R2.2 HUMAN REVIEW PACK

R2.2 Critical Issues

R2.2 Critical Issues — current latest-FCStd positions only

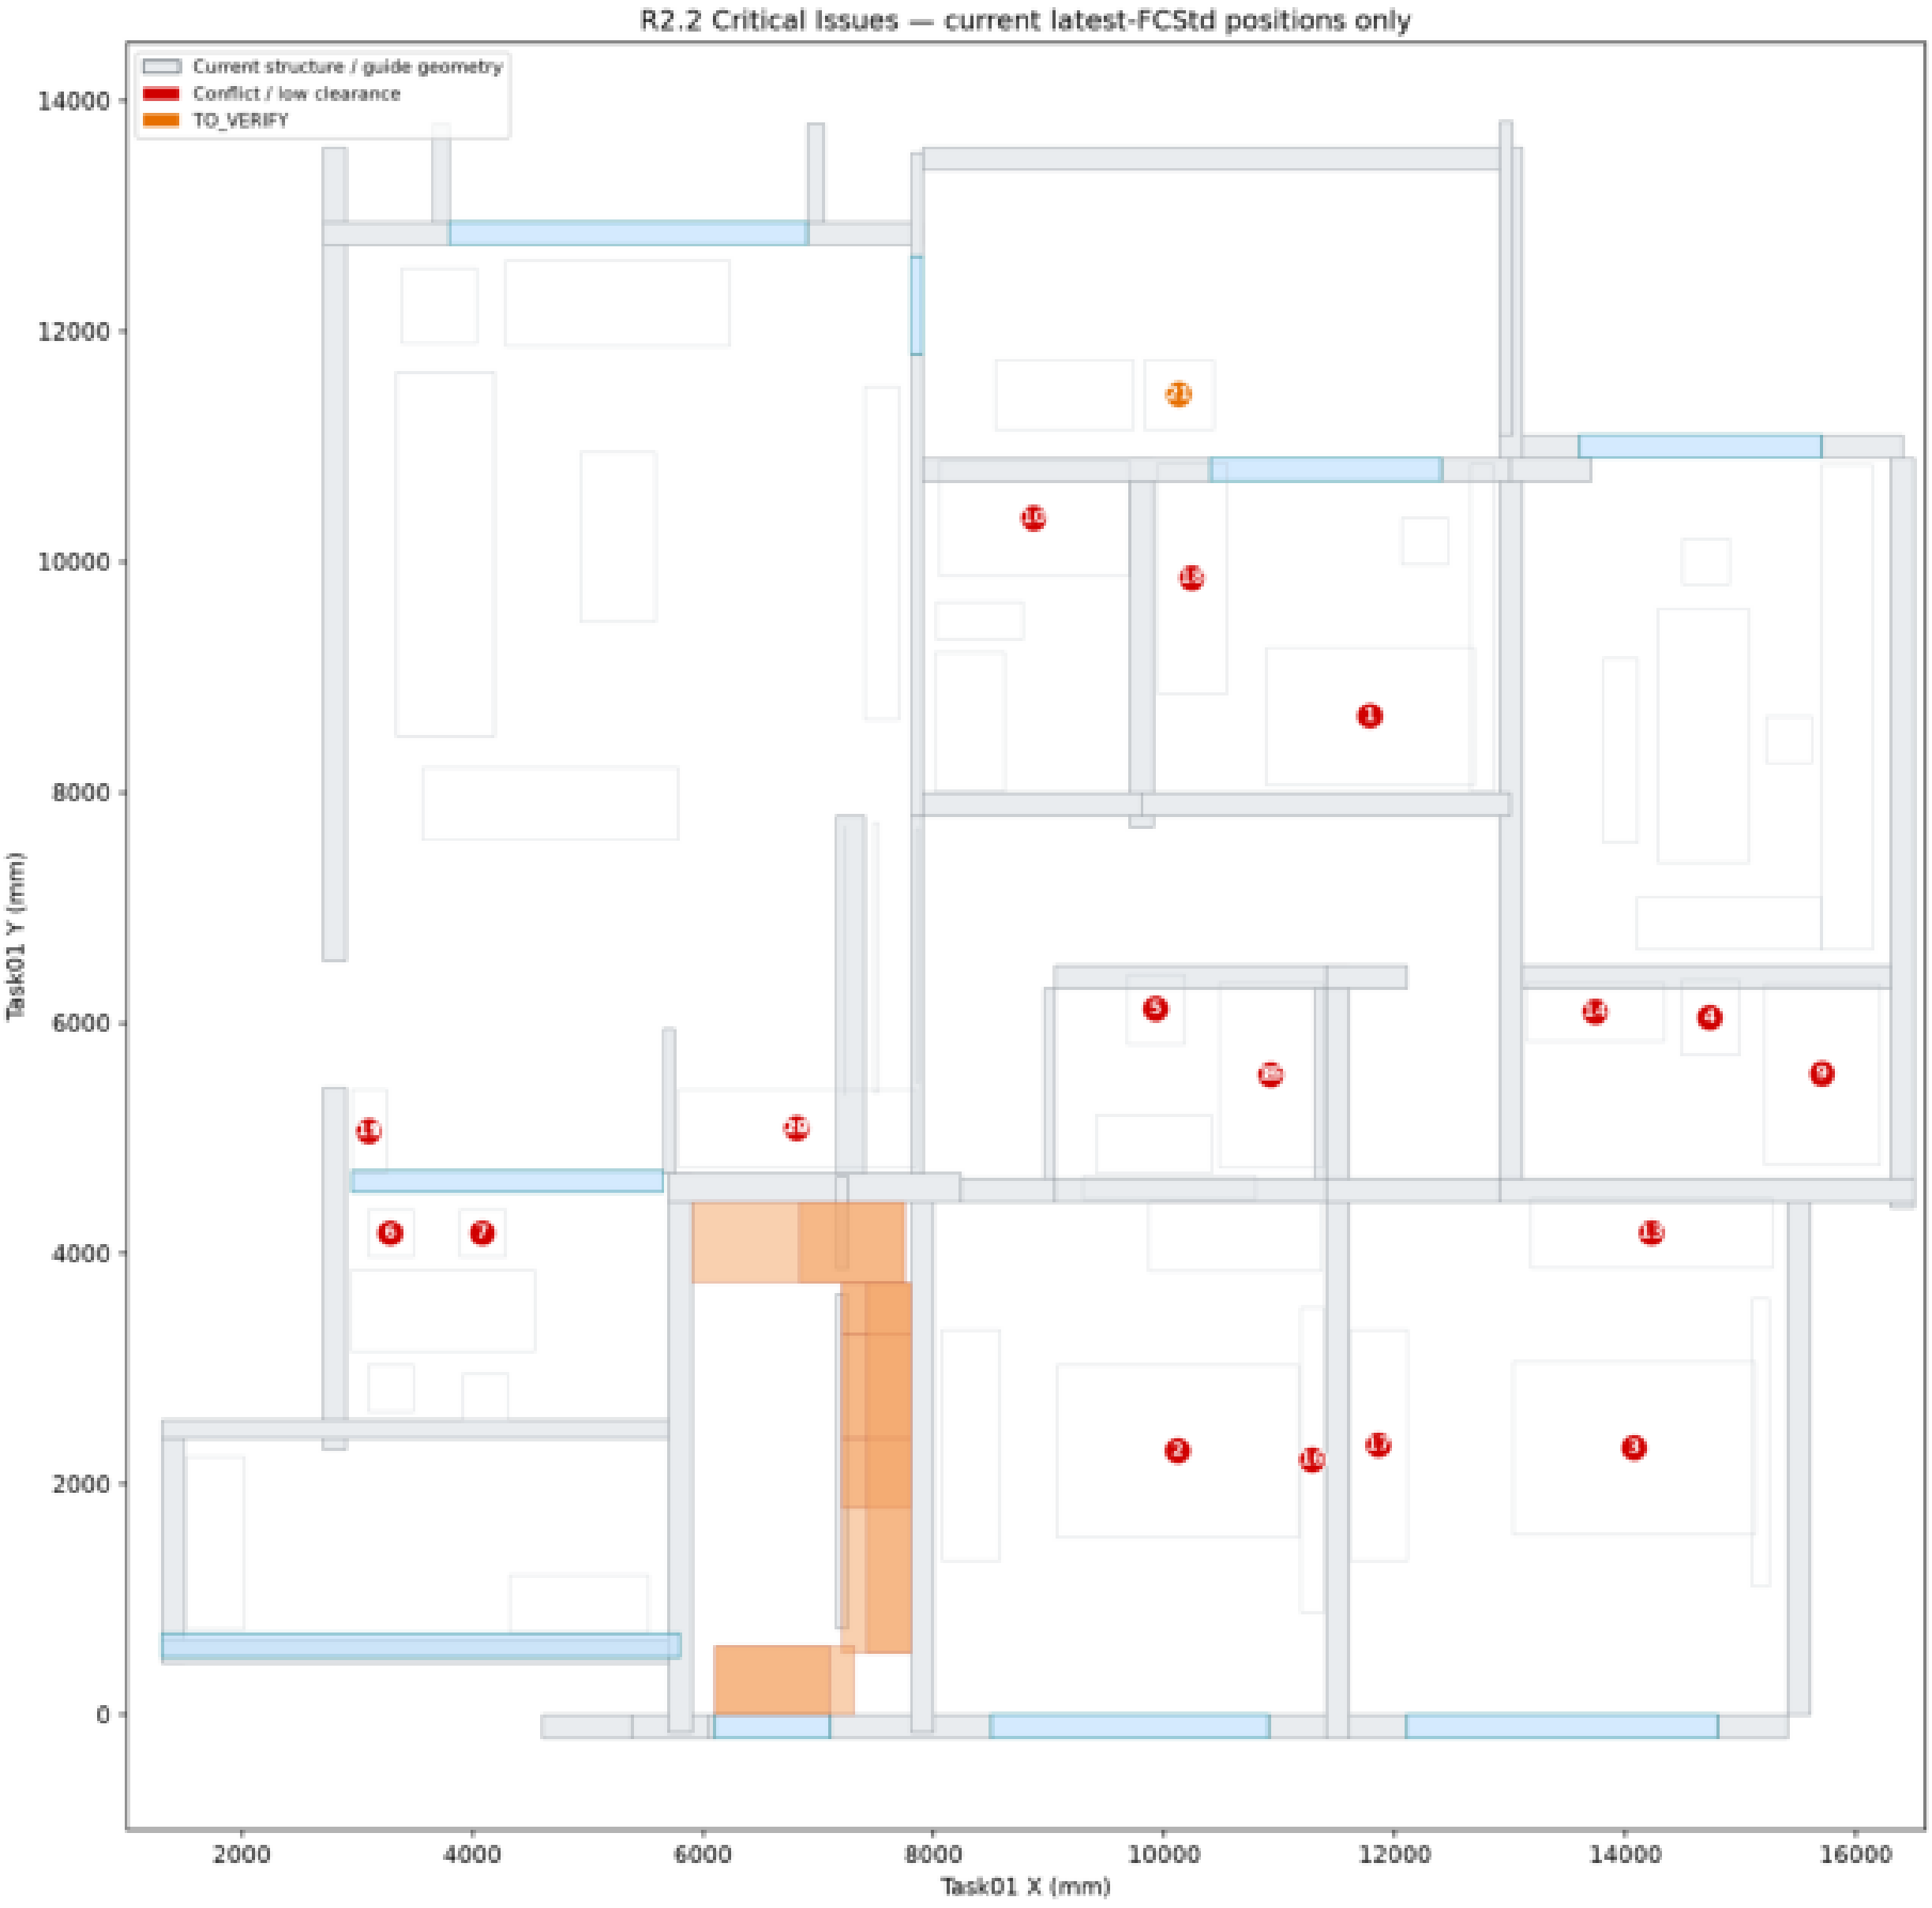
[illegible] front clearance: -120.8 / target 800 / CONFLICT / shortfall 920.8 mm / HUMAN DECISION REQUIRED

[illegible] side clearance: 173.6 / target 600 / CONFLICT / shortfall 426.4 mm / HUMAN DECISION REQUIRED

[illegible] front clearance: -71.1 / target 800 / CONFLICT / shortfall 871.1 mm / HUMAN DECISION REQUIRED

[illegible]1.2 side clearance: 215.4 / target 600 / CONFLICT / shortfall 384.6 mm / HUMAN DECISION REQUIRED

[illegible]1.2 foot clearance: 1437.8 / target 600 / PASS / none / NO CHANGE REQUIRED [illegible] side clearance: 233.4 / target 600 / CONFLICT / shortfall 366.6 mm / HUMAN DECISION REQUIRED

[illegible] / balcony door: — / target 100 / CONFLICT / 0 mm minimum distance; overlap 22,014.6 mm² / HUMAN DECISION REQUIRED

[illegible] table gap: 121.1 / target 150 / CONFLICT / shortfall 28.9 mm / HUMAN DECISION REQUIRED

[illegible]003 table gap: 121.1 / target 150 / CONFLICT / shortfall 28.9 mm / HUMAN DECISION REQUIRED
